*PATHFINDER MINES  
CORPORATION  
SHIRLEY BASIN MINE*

*TAILINGS RECLAMATION  
PLAN*

**RE: Docket No. 40-6622, Source Material License SUA-442  
Pathfinder Shirley Basin Tailings Reclamation**

RE: RESPONSE TO N.R.C. STAFF REVIEW COMMENTS  
PATHFINDER MINES CORPORATION RECLAMATION PLAN  
SHIRLEY BASIN URANIUM MILL SITE  
SHIRLEY BASIN, WYOMING

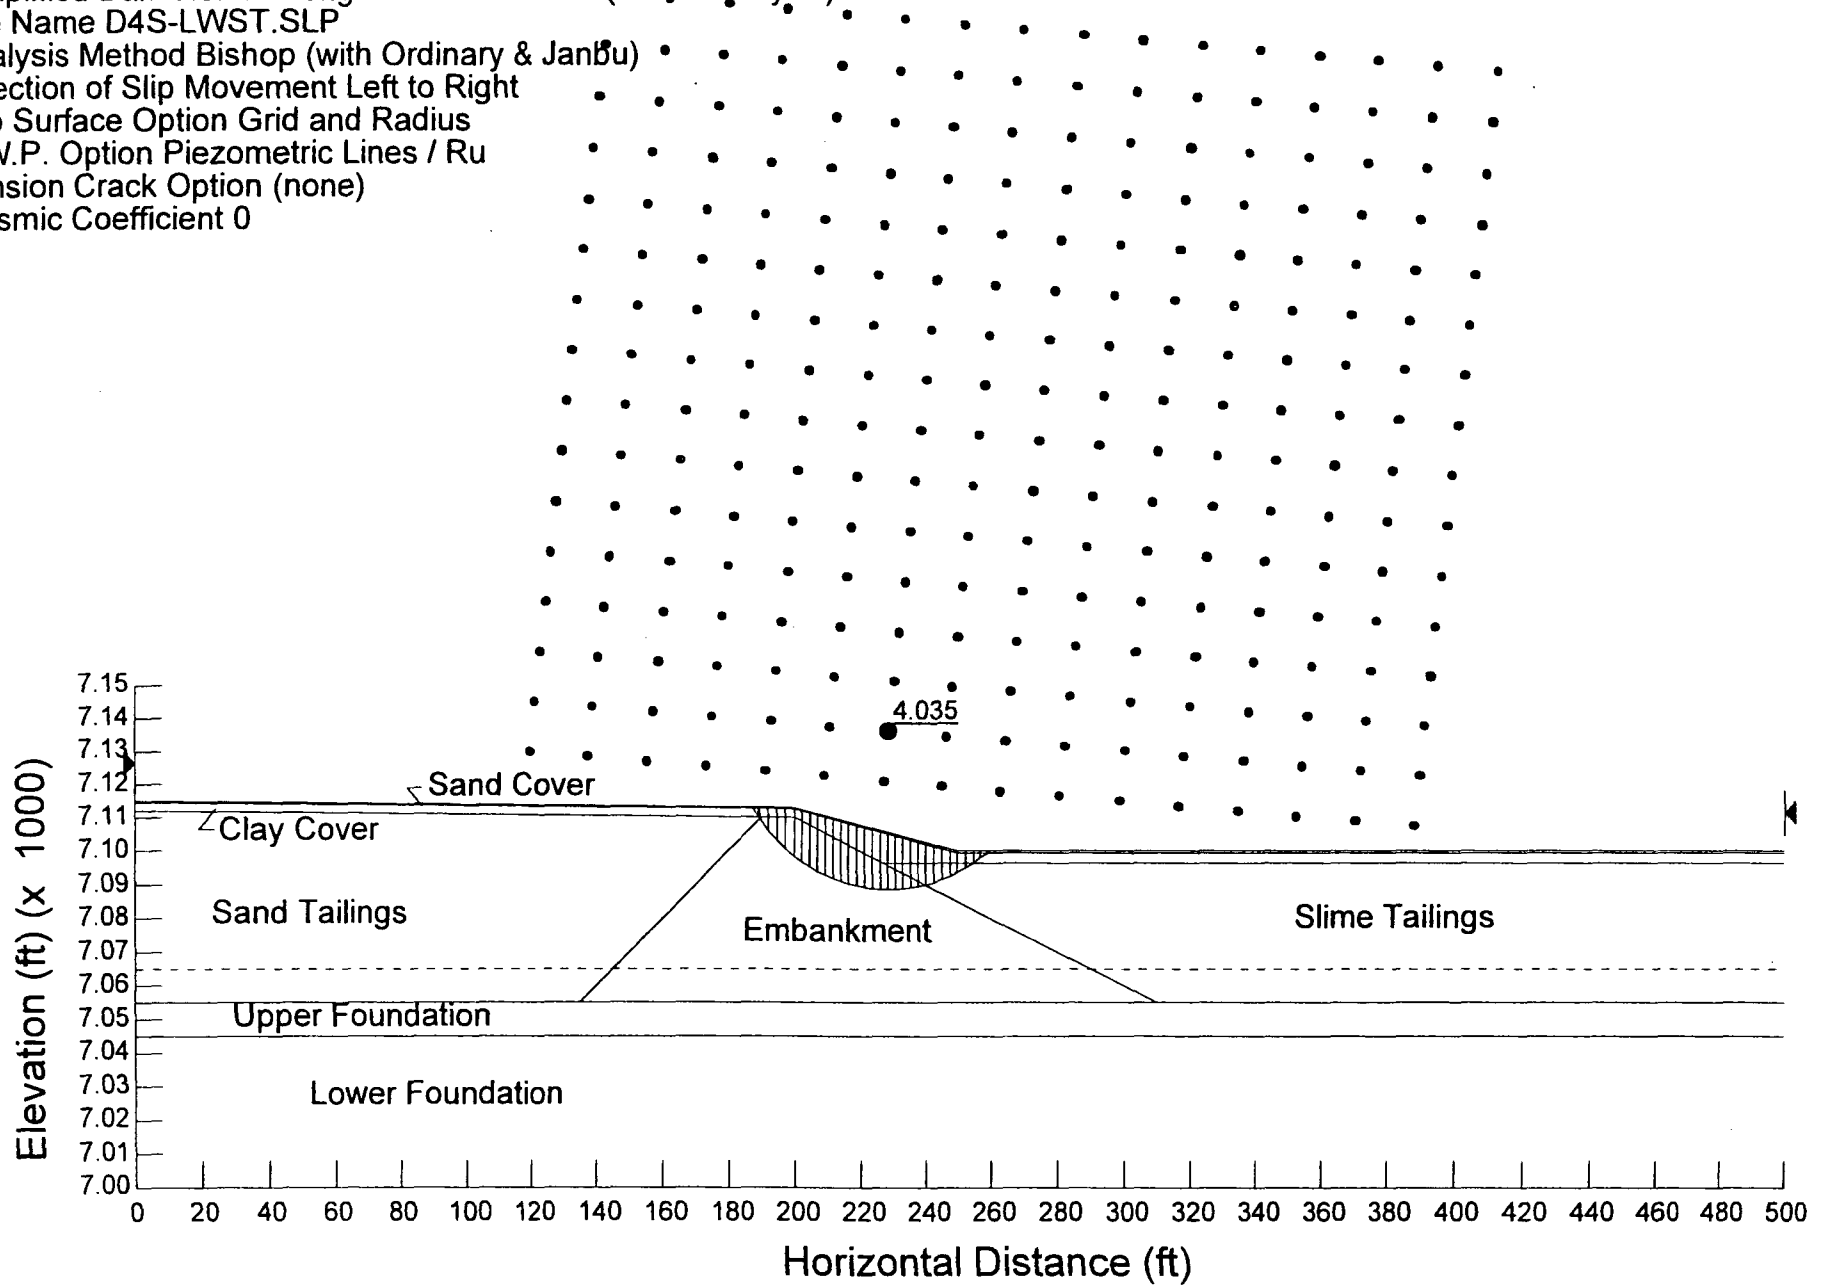
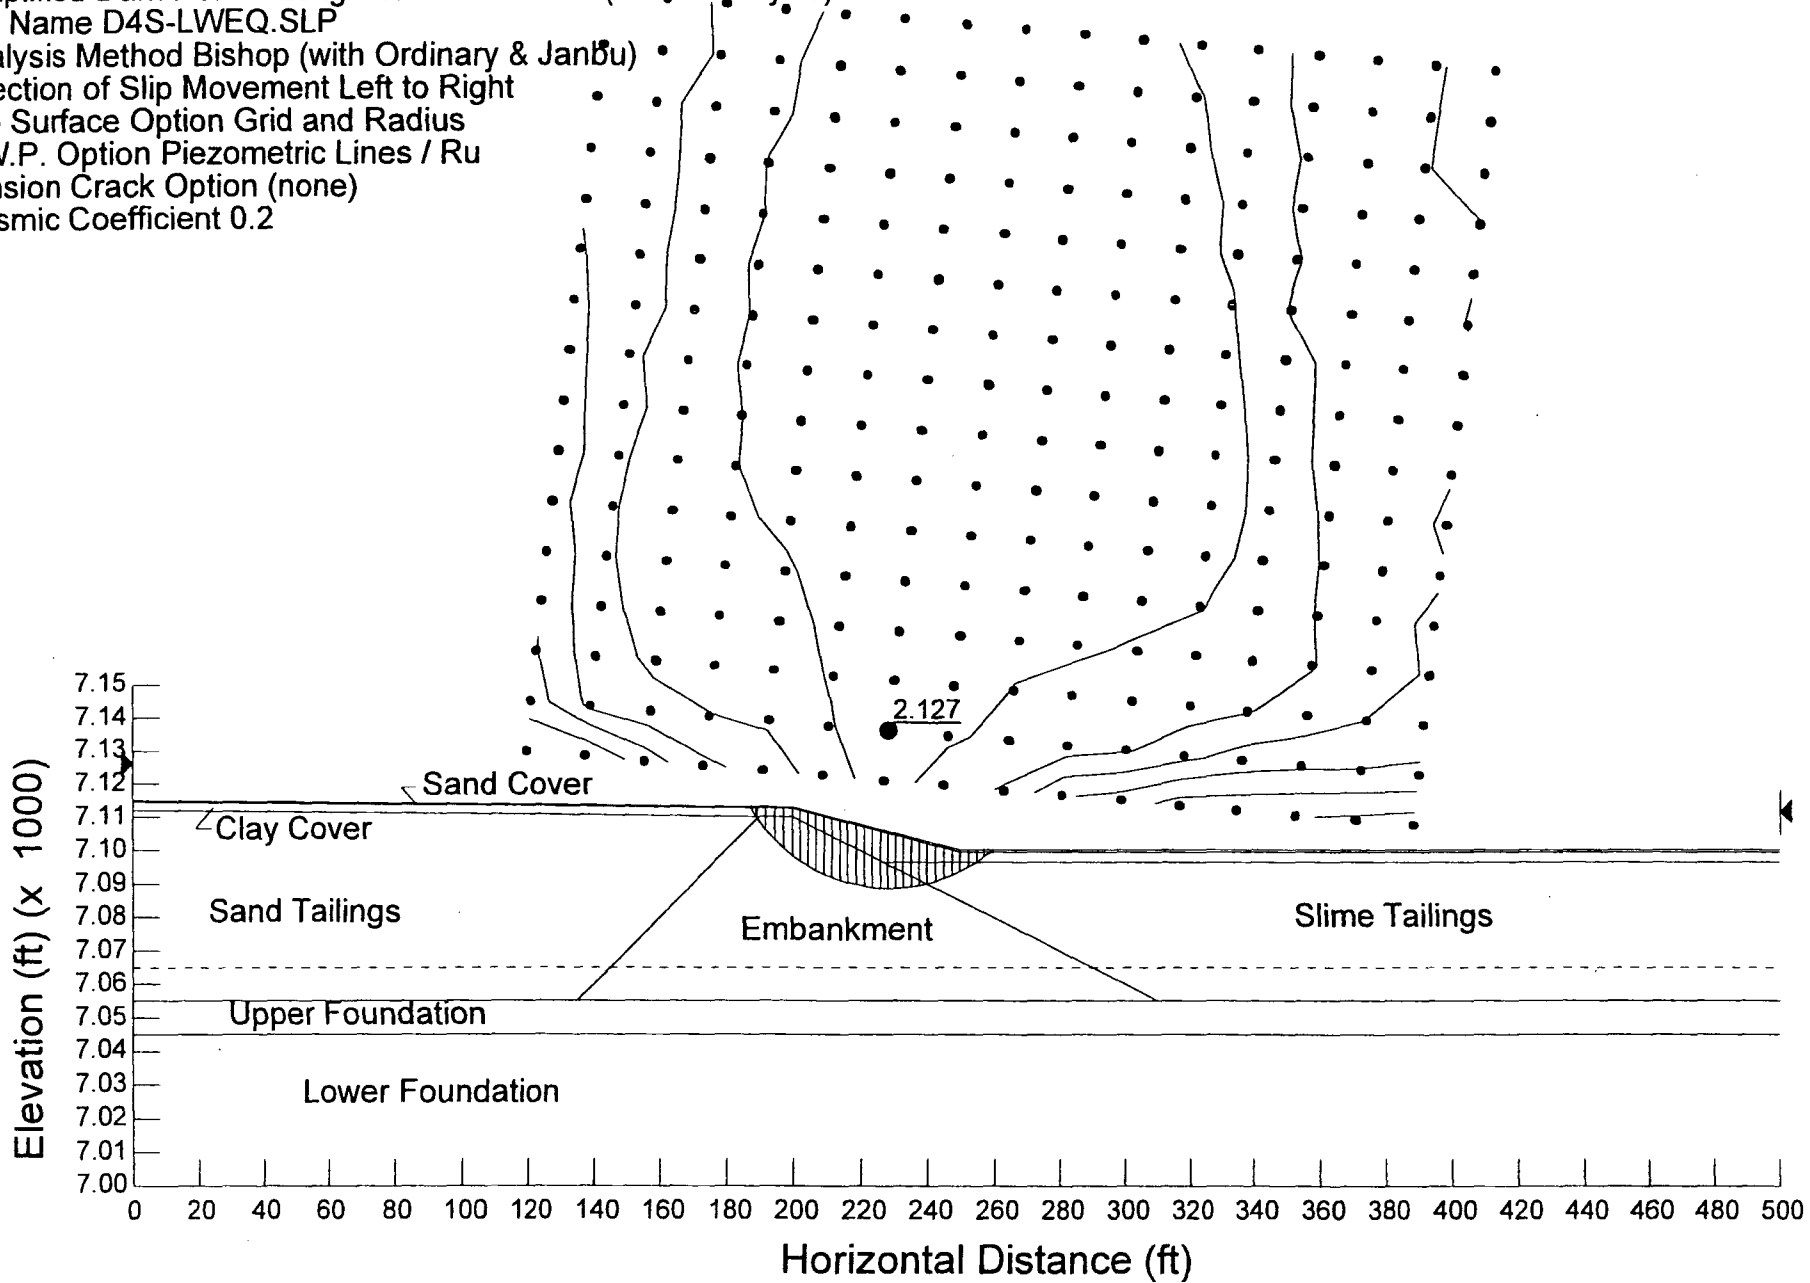
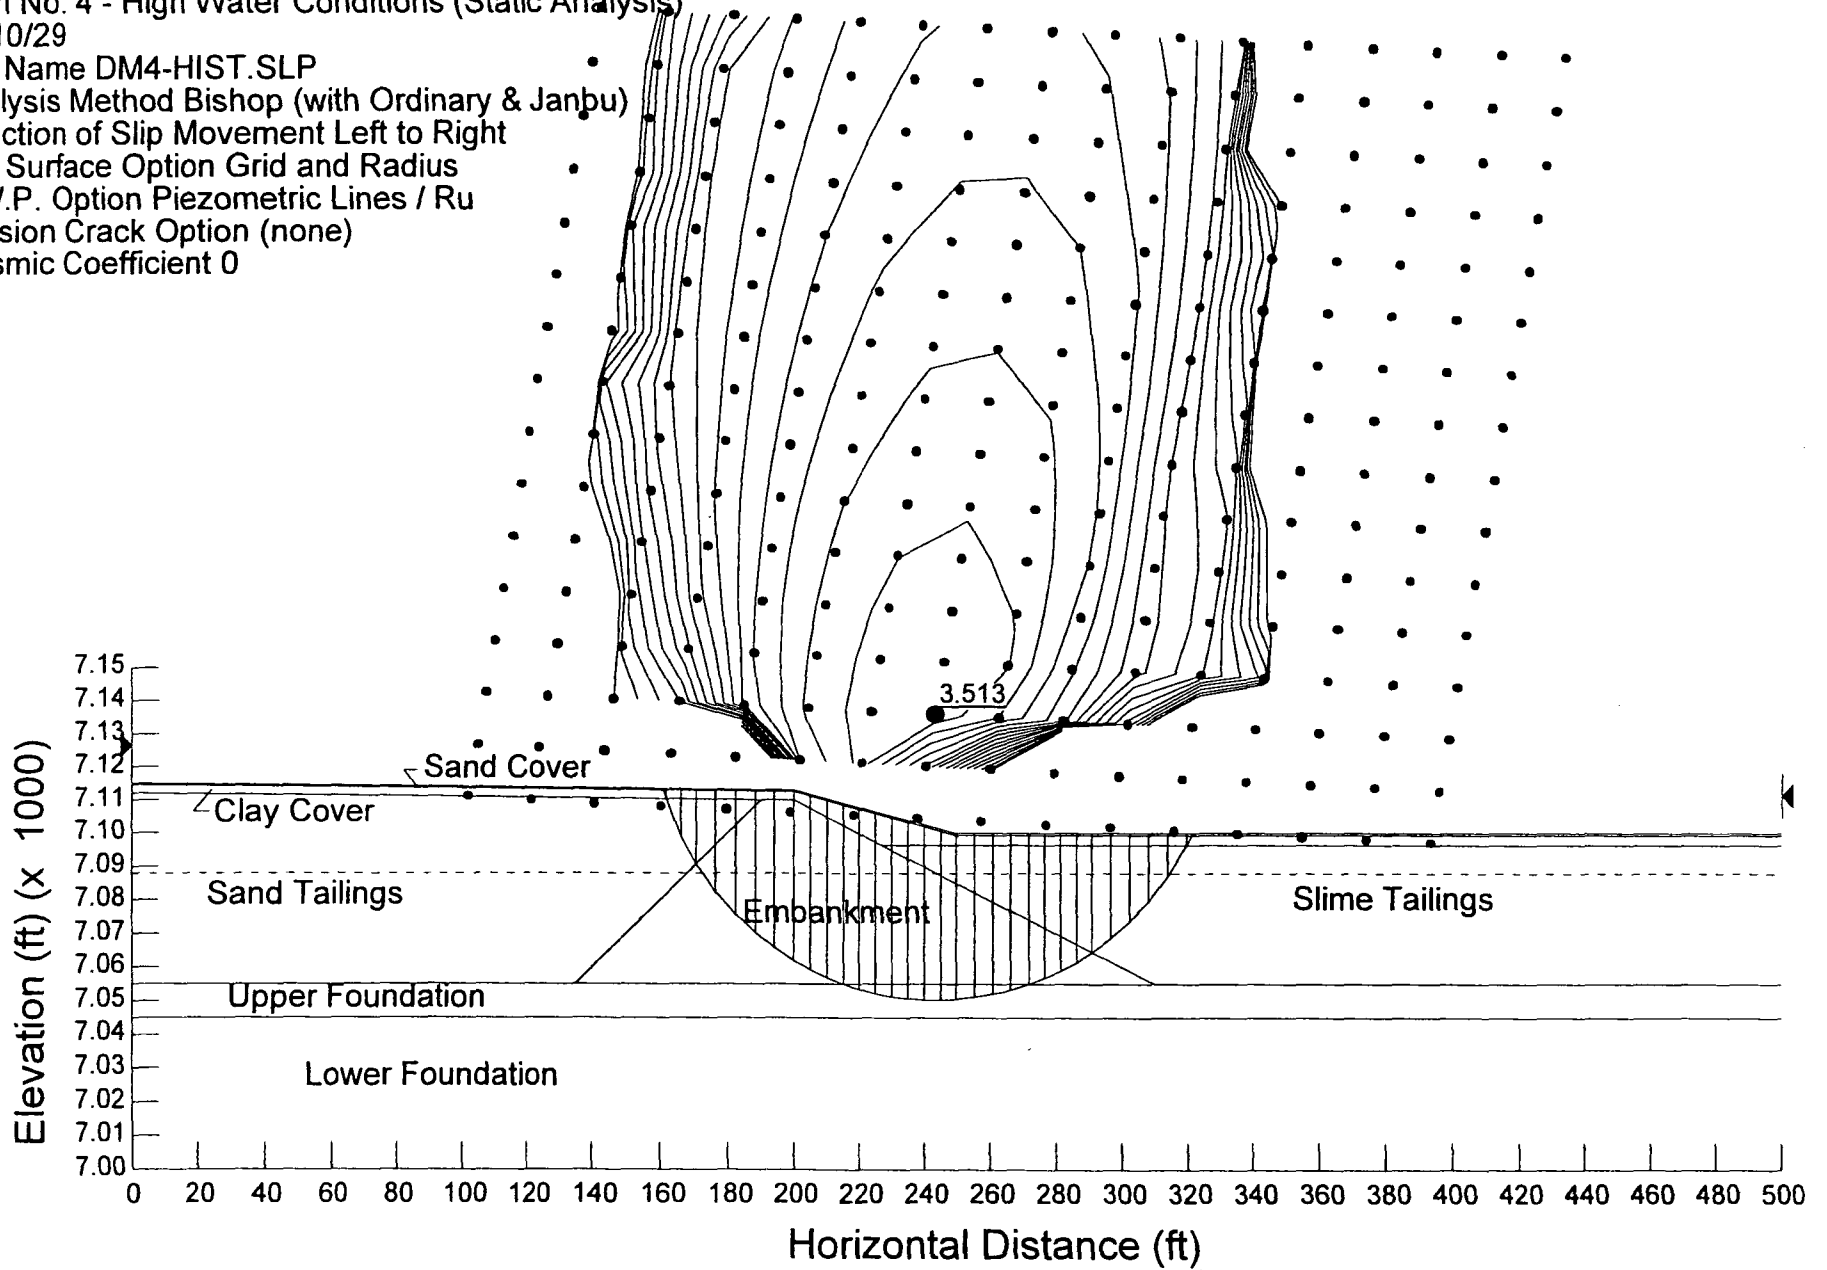
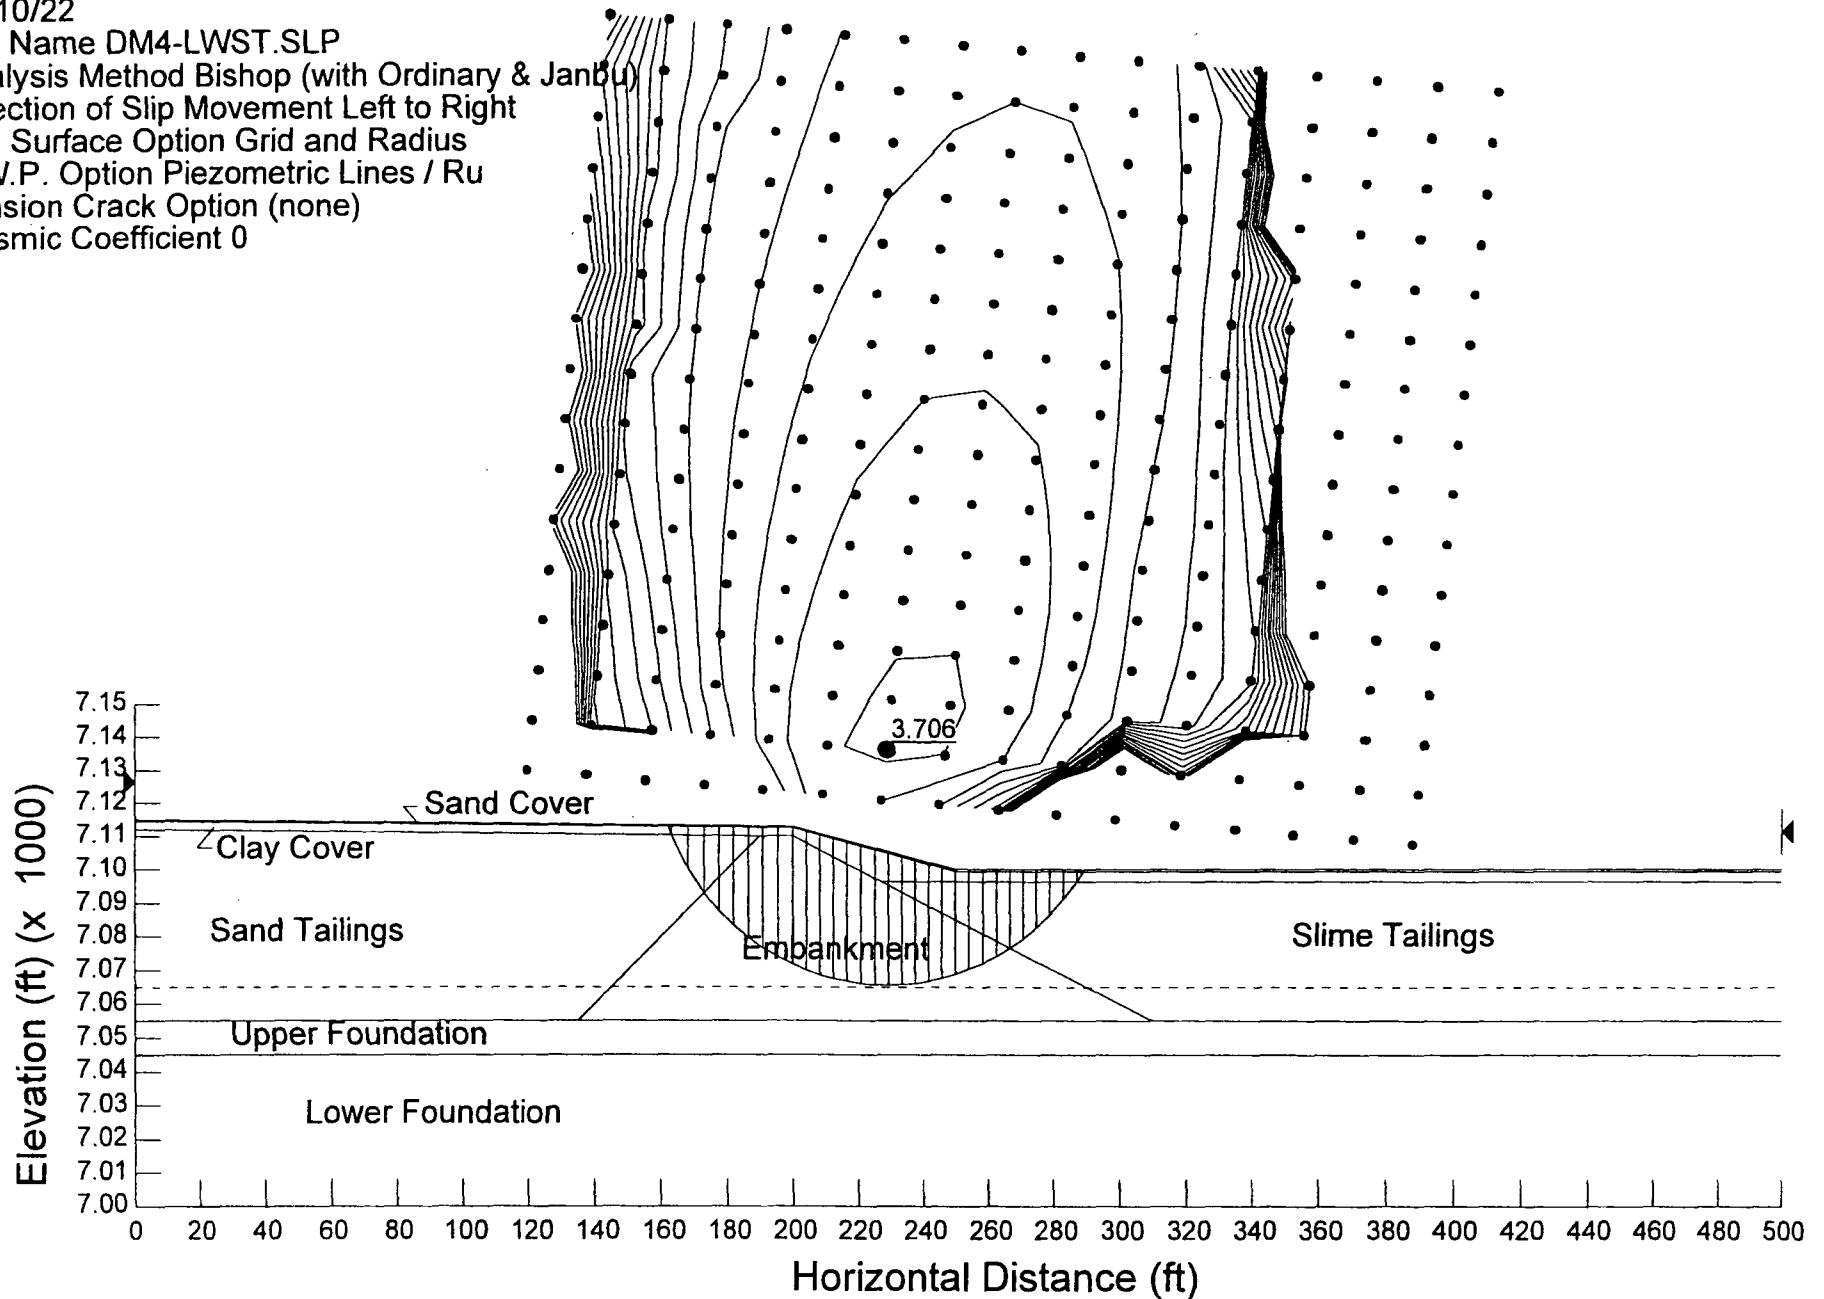
This letter summarizes our response to the NRC's staff review comments (items No. 1 and 2) regarding the slope stability and liquefaction potential analyses for Dams No. 4 and 5 at the above-referenced project. The NRC is requesting additional information regarding: 1) documentation of soil parameters used in the slope stability analyses, and 2) additional consideration of the methodologies used in the stability analyses. More specifically, an evaluation of the stability analyses is requested regarding: i) the effects of variations associated with the geometry of the slopes, soil and rock parameters, and pore pressures acting within the slopes, and ii) effects of the assumptions inherent in the Modified Bishop's Method. In addition, further discussion of the liquefaction potential and the selection of soil parameters related to: i) material strength loss, and ii) pore pressure development due to dynamic loads.

shear strength of the clayey foundation soils. In light of this, Dam No. 4 was reanalyzed for the purpose of this response using the foundation soils from Dam No. 5. The results of the analysis are tabulated below, and plots of the analyses are enclosed.

In order to evaluate the conservative nature of variations in soil parameters, it is important to consider the results of the modified Dam No. 4 analysis discussed previously. Since the shear strength of sandy soils is less than the clayey soils, using the sandy foundation soils would result in the most conservative results. The Dames and Moore reports state that in the original design for Dam No. 5 the maximum shear strength of the sandy foundation soils is 4900 psf. However, from the original analysis of Dam No. 4, it can be observed that the bottom of failure surface for the high water seismic analysis is tangent to an elevation at approximately 7050. Shear strength at this depth is approximately 1300 psf. Any variations of soil parameters resulting in a shear strength greater than 1300 psf would exhibit conservative results.

Variations in geometry for Dam No. 4 would not effect stability analyses significantly because the critical failure surfaces are controlled by the shear strength of the foundation soils. However, variations in the geometry for Dam No. 5 would affect stability results. The stability analysis for Dam No. 5 was performed on the maximum cross-section. The most critical failure condition occurs at high water conditions under seismic loading. Additional stability analysis event at a downstream slope of 3:1 instead of the previously analyzed 4:1 slope, results in minimum factor of safety of 1.10. Additionally, we understand that the final reclamation plan, as currently being revised, flattens the down stream slope to 5:1 which would result in more conservative results than the 3:1 and 4:1 analyzed slopes.

In our opinion, the modified Bishop's Method yields conservative results for both static and pseudo-static analyses. Due to both embankments being constructed of generally cohesive materials, it is reasonable to assume that a circular failure surface would occur within the embankments. The modified Bishop's Method is based on moment equilibrium. However, it is also useful to evaluate force equilibrium methods to compare the conservatism of the analyses. The most common force equilibrium method is the Janbu Method of analysis. The following tables summarize the minimum factors of safety based on the Janbu Method.
